SAM G55 Series Family Silicon Errata and Data Sheet Clarification

The SAM G55 Series family of devices that you have received conform functionally to the current Device Data Sheet (Atmel-11289F-ATARM-SAM-G55G-SAM-G55J-Datasheet_27-May-16), except for the anomalies described in this document.

Data Sheet Clarifications

8. Module: USART - Transmitter Operations

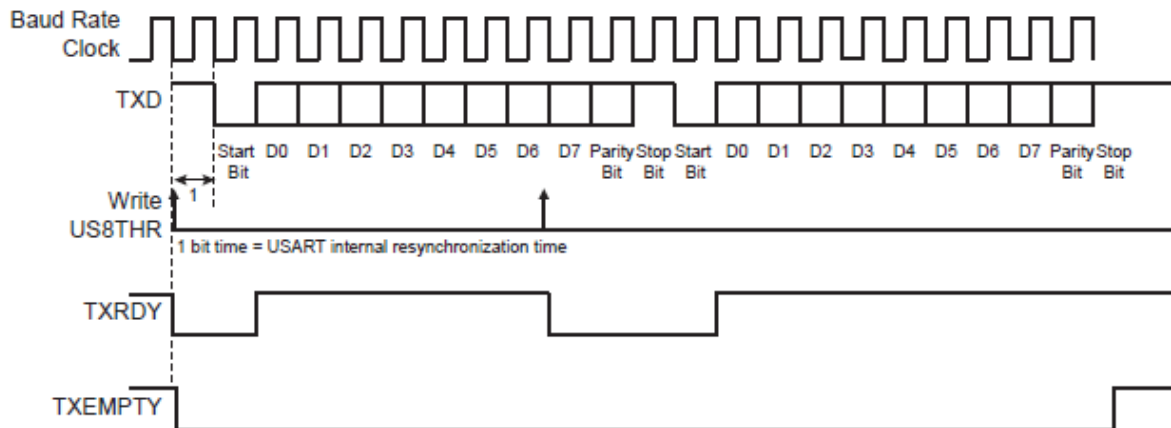
Figure 30-6 is incorrect. The corrected figure is as shown below:
